## AMENDMENT-XXV

**Ref.: IFB No. HSCC/SJH/Medical Equipment/2016/26 Dated 04.01.2017**

Sub.: Procurement of Medical Equipment for New Emergency Block & Super- Specialty Block at Safderjung Hospital, New Delhi.

The queries regarding technical specification and site layout has been received for item no. 1, Brain Suit MRI and Item no. 2 DSA Flat Panel and please find attached the modified site layout plan for the following equipments.

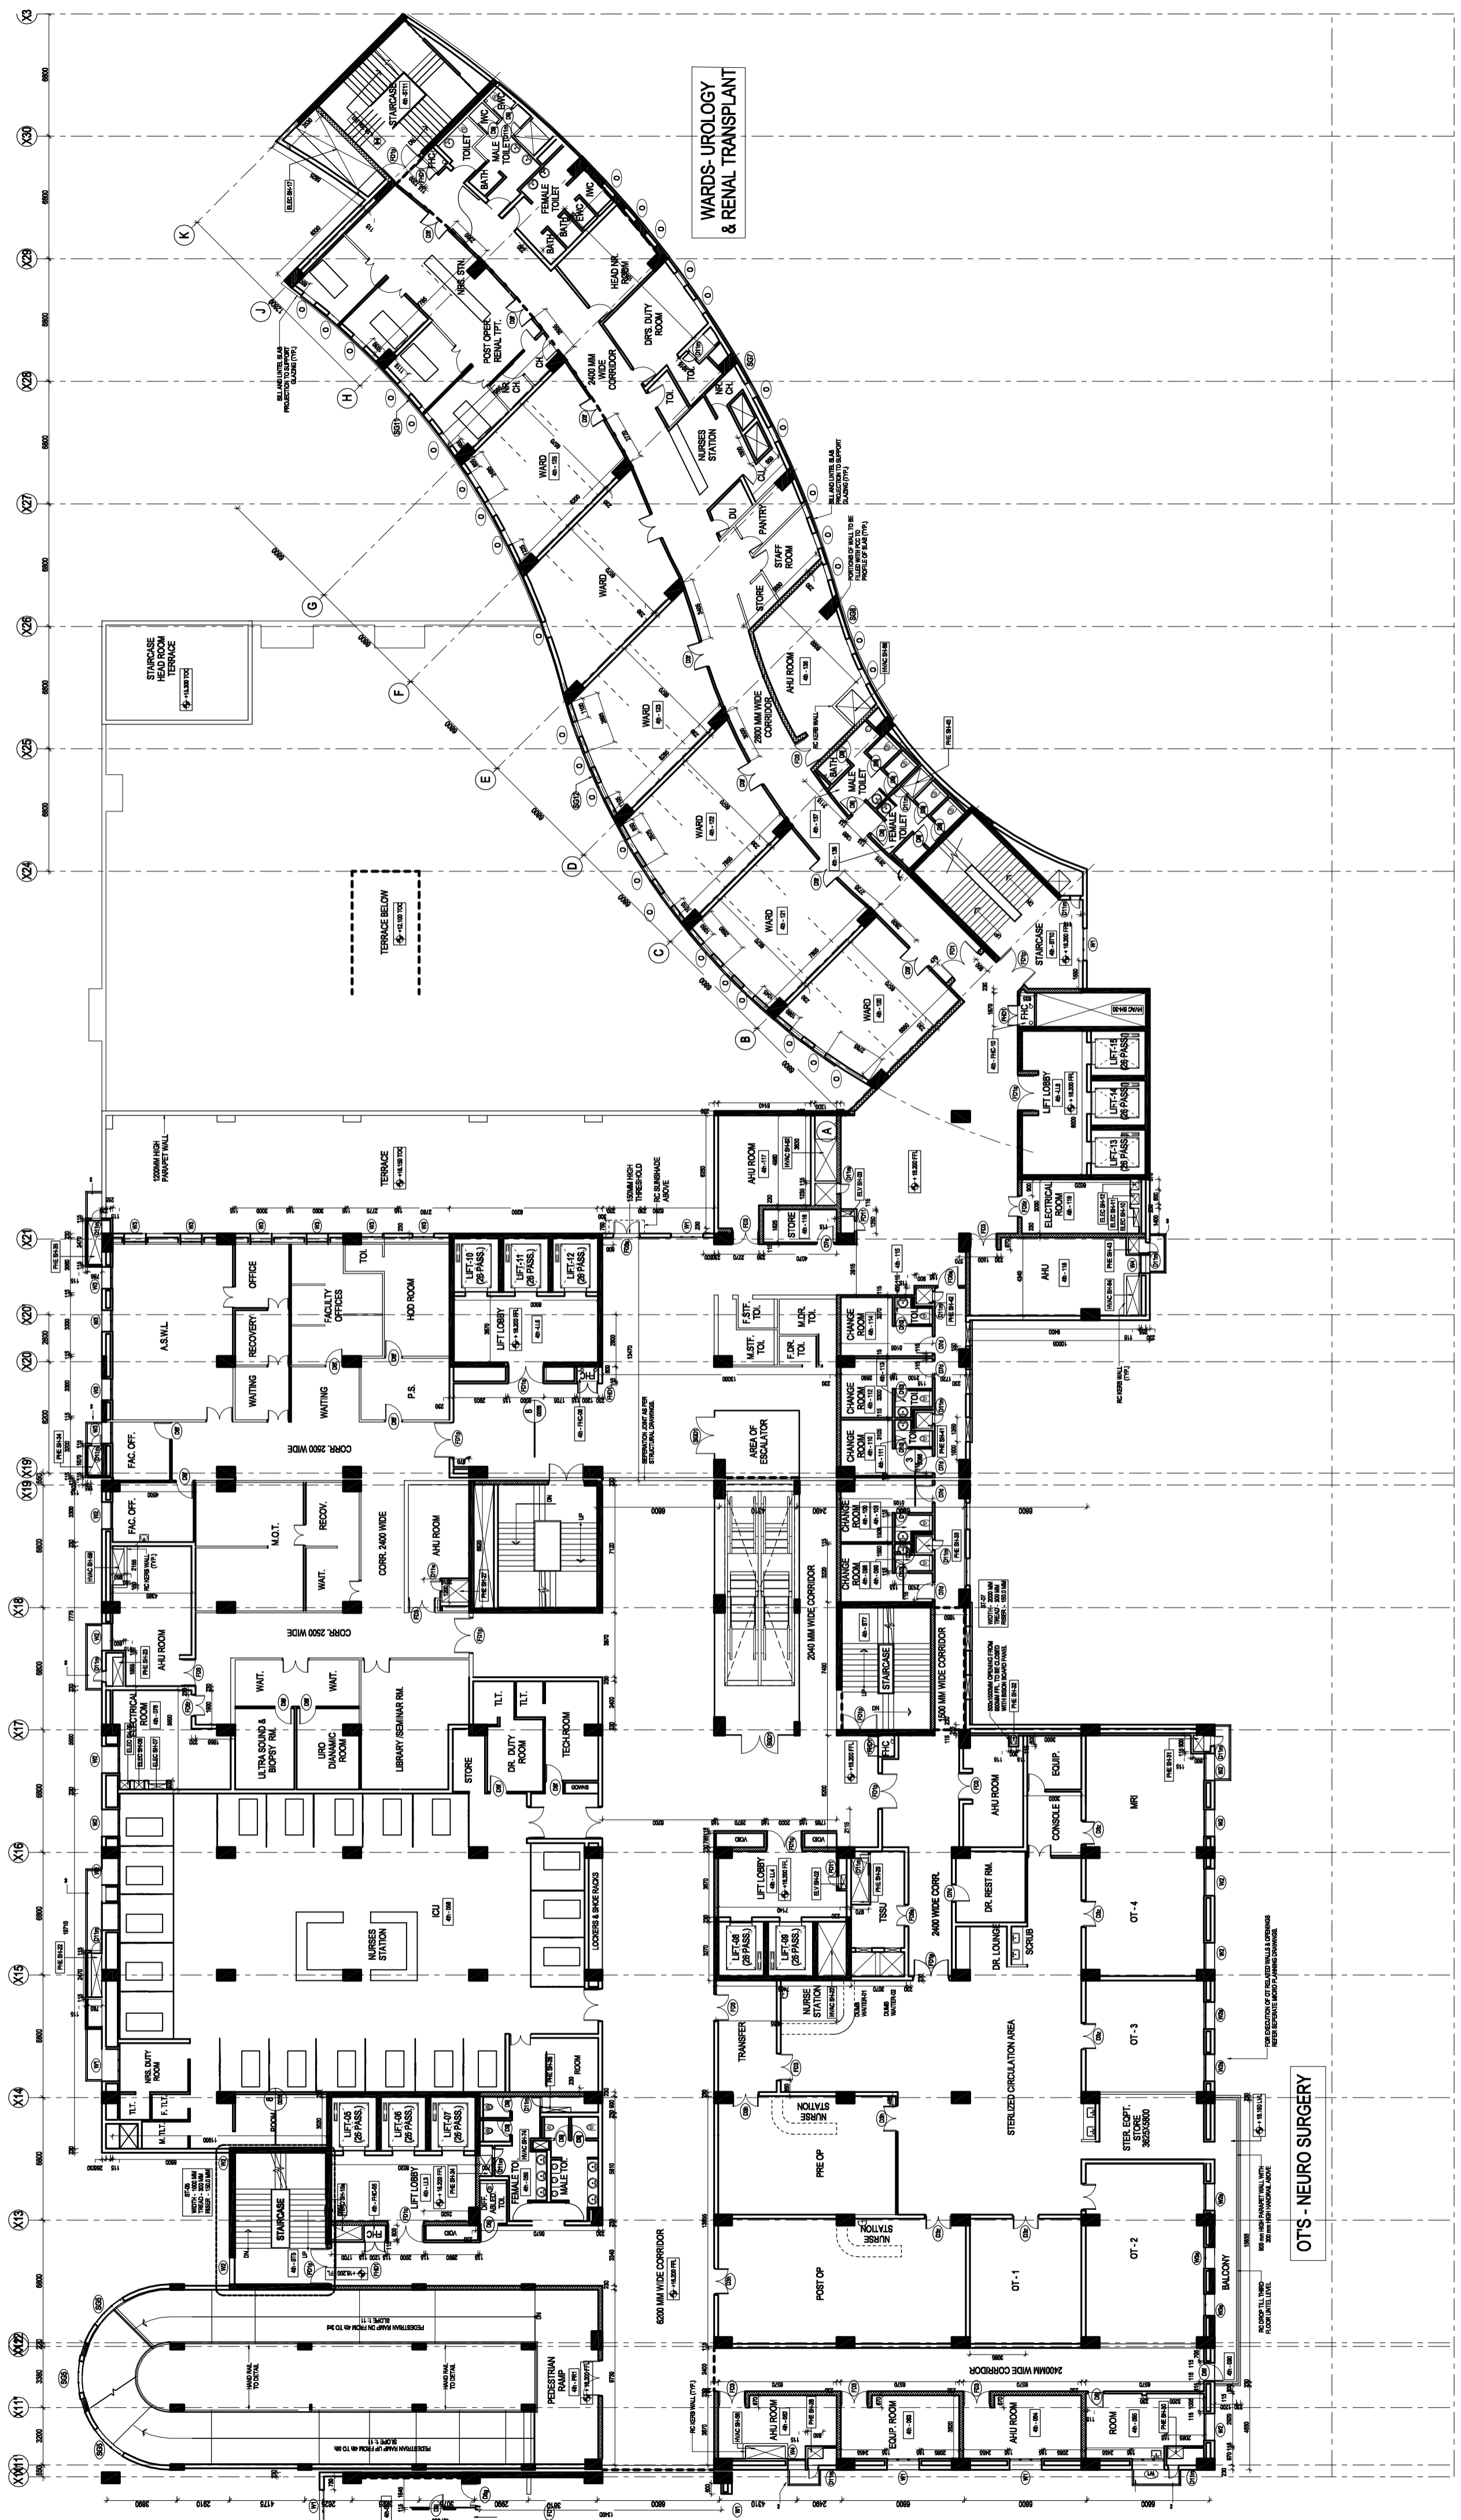
Brain suit area is located on the 4<sup>th</sup> floor of the SSB Block is consist of OT -4, MRI room, Console Room and Equipment room.

Regarding Flat Pannel DSA it is located in basement 1<sup>st</sup> Floor in SSB Block. DSA Consist of DSA Room, Console Room, Prep /Recovery Room Two Changing Room with lobby.
